LOEHMANN'S PLAZA

PRELIMINARY PLAN AMENDMENT NO. 12024010A

SITE PLAN AMENDMENT NO. 82024012A

The Applicant proposes to widen Lauderdale Drive from 65 to 68 feet to accommodate large trucks (WB-67) for delivery to a future grocer and provide other minor adjustments.

Figure 5 –Preliminary Plan and Site Plan Amendment Proposal

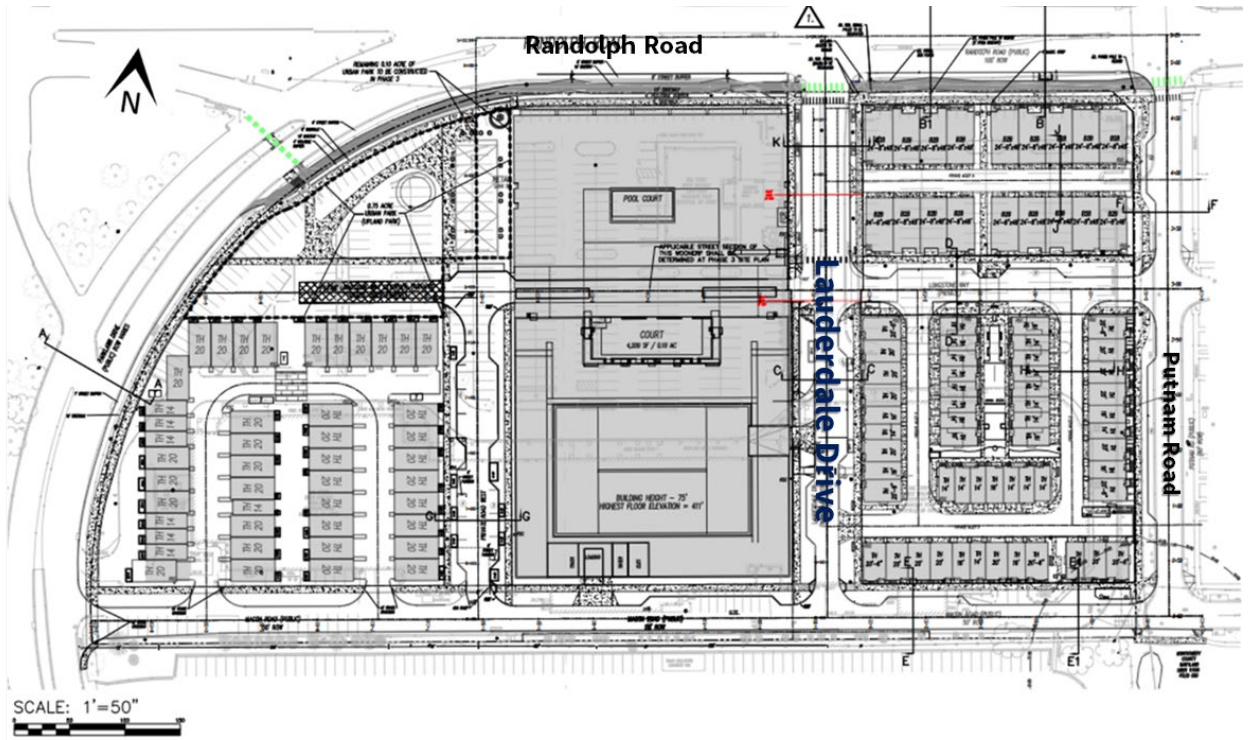
Rosenfeld Investment, LLC, the applicant, (“Applicant”) proposes to make modifications to Lauderdale Drive to accommodate the grocery delivery trucks up to the size of a WB-67. The following are items to be modified:

- Right-of-way section for Lauderdale Drive will increase from 65 feet to 68 feet, requiring a lot line adjustment.
- The vehicular/pedestrian signals at the intersection of Randolph Road and Lauderdale Drive will need to be reconfigured.
- New separate crossings for the bicycles and pedestrians at this intersection crossing will be provided.
- The western ingress lane will become a right-turn-only lane into the existing large retail parking lot at Longstone Way.
- Westbound WB-67 trucks on Randolph Road will be able to access the Property (egress of the WB 67 trucks will remain onto northbound Parklawn Drive).

Figure 7 – Redline Loading Plan

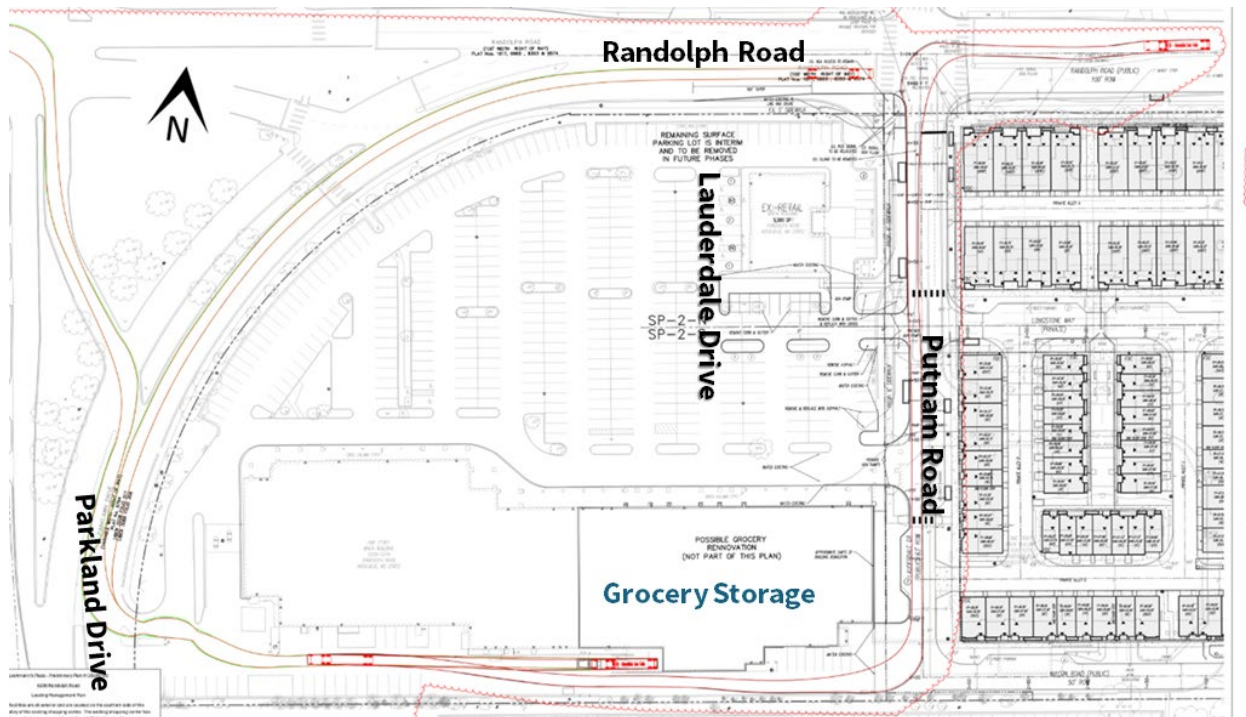
The loading access will be limited to trucks no larger than a WB-67, which is a change from the previously analyzed and approved WB-50 (smaller truck). WB-67 trucks must access the site from the east along Randolph Road and are limited to westbound left-turn movements. WB-67 trucks will exit the Site via the existing driveway access on Parklawn Drive. All other loading is limited to

12. Prior to certification of the Preliminary Plan, the Applicant must submit a Loading Management Plan that limits the Site to a loading design vehicle no larger than a ~~WB-50~~ ~~67~~ truck. ~~WB-50-67~~ loading operations are limited to an inbound westbound left-turning movement at the intersection of Randolph Road and Lauderdale Drive and an outbound westbound right-turn at the Parklawn Drive driveway access. All other loading inbound and outbound movements are limited to a single-unit truck (SU-30). Final signage locations to be reviewed and approved by DPS at the time of right-of-way permit associated with the Phase 1
